VILLAGE OF BARRINGTON HILLS

Board of Health **NOTICE OF MEETING**

Re: Septic Review- 22 Spring Lane
Review #1

Re: Water Quality Monitoring

Figure 1 Proposed Water Quality Sampling Locations

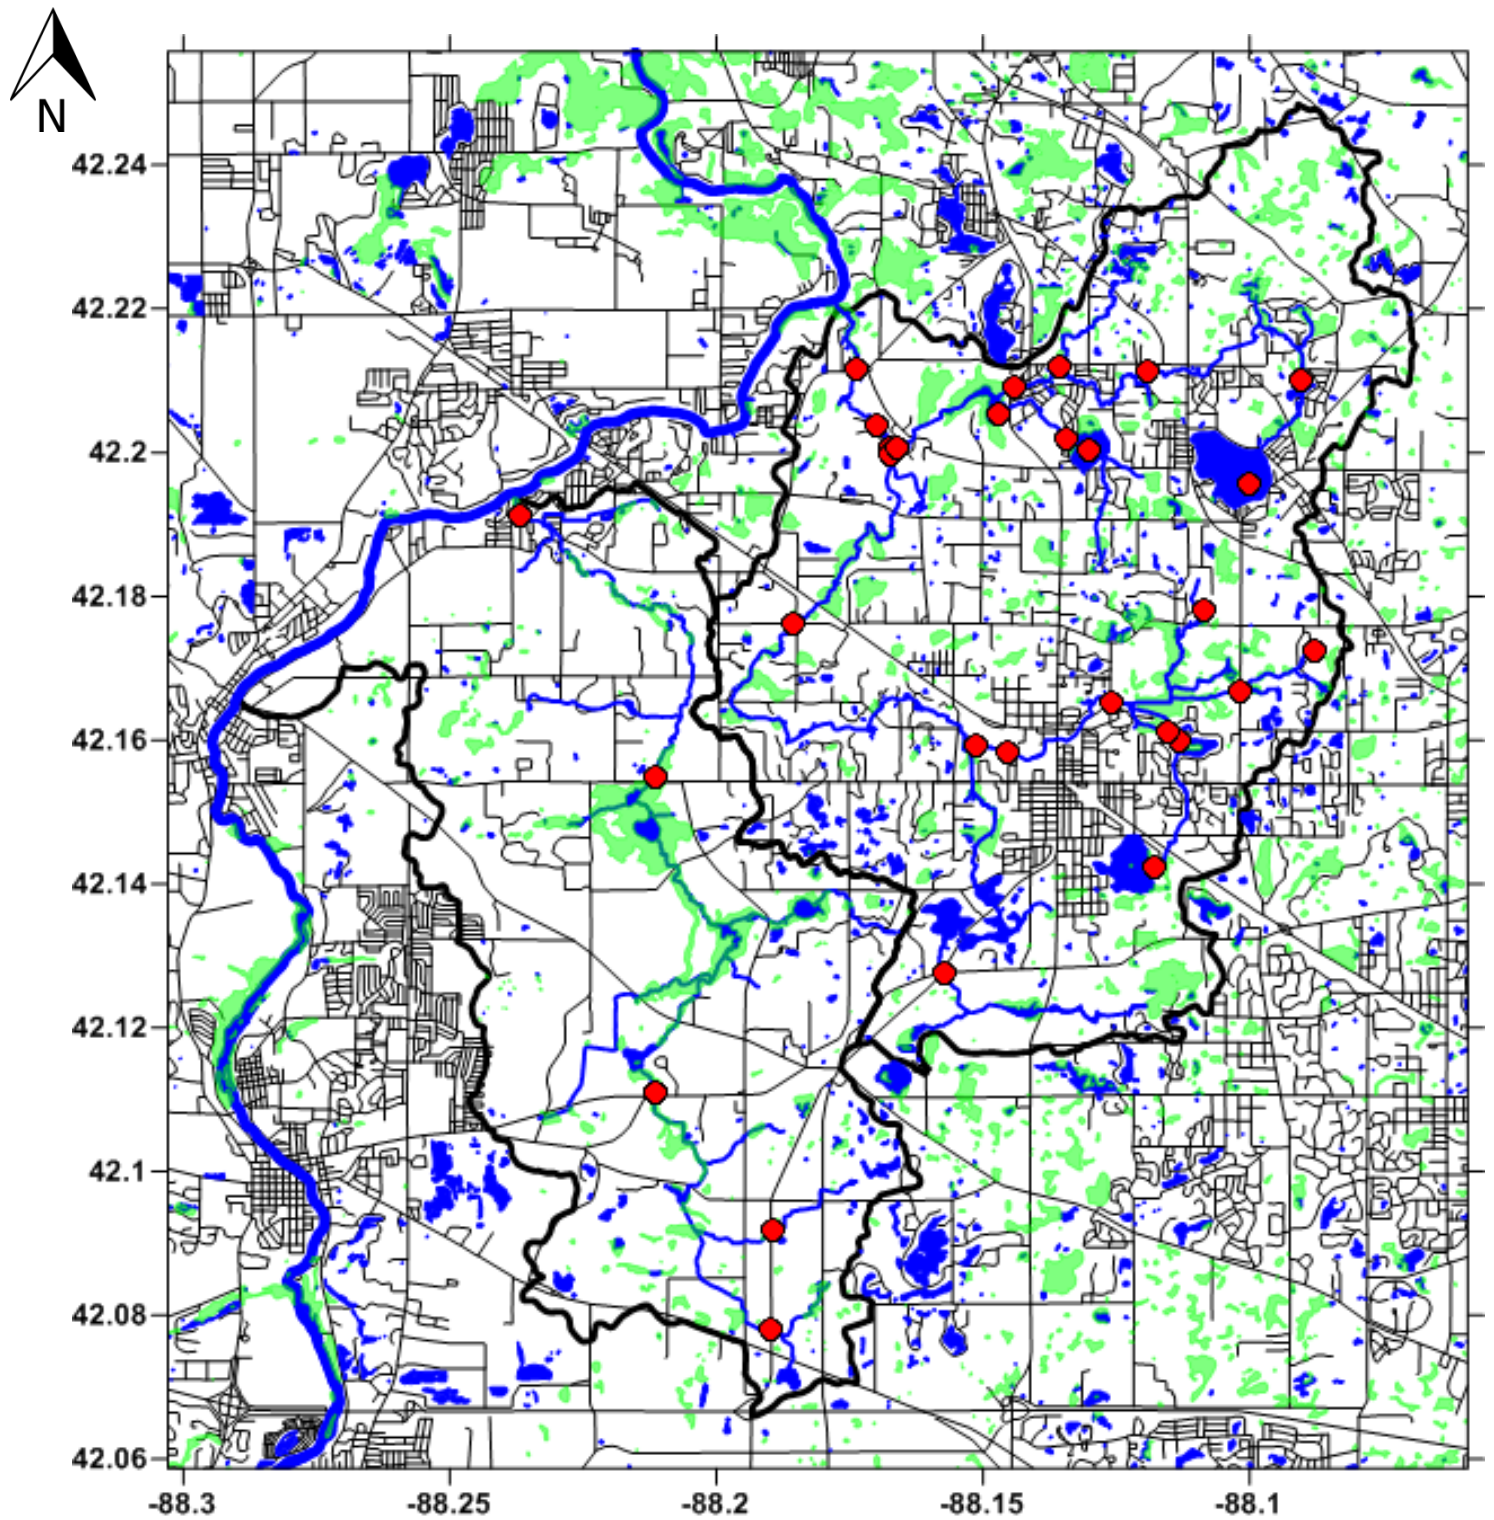
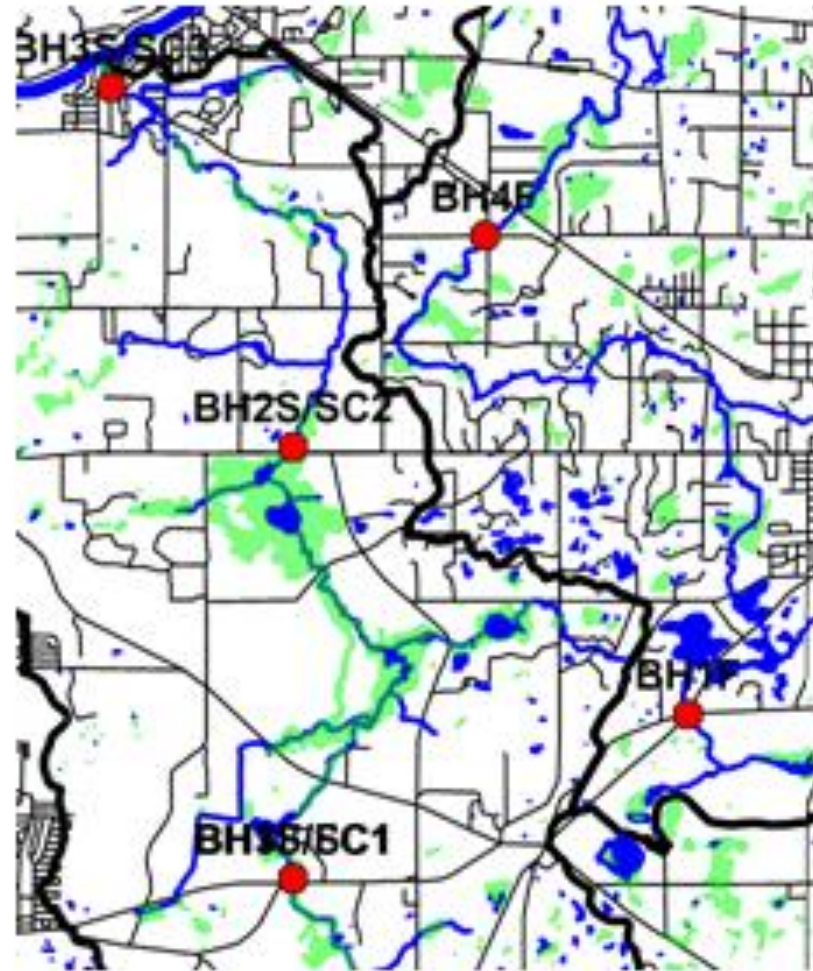
Flint Creek Watershed Partnership and Spring Creek Watershed Partnership through their not-for-profit fiscal agent, Citizens for Conservation, propose to implement the water quality monitoring plan that is currently being prepared for the Flint and Spring Creek watersheds (Figure 1) to establish baseline water quality characteristics. Implementation will take place in FY 15. The establishment of baseline water quality characteristics of the watersheds and continued monitoring will allow us to; 1) assess the current state of water quality resulting from non-point source pollution within streams and lakes; 2) assess changes in water quality to see how well implemented BMPs are working to remove pollutants for meeting water quality targets and ultimately milestones and project goals; and 3) assess the public social behavior related to water quality issues. Water quality monitoring will be performed by collecting physical, chemical, biological and social indicator data related to the watershed-based plans goals and objectives.
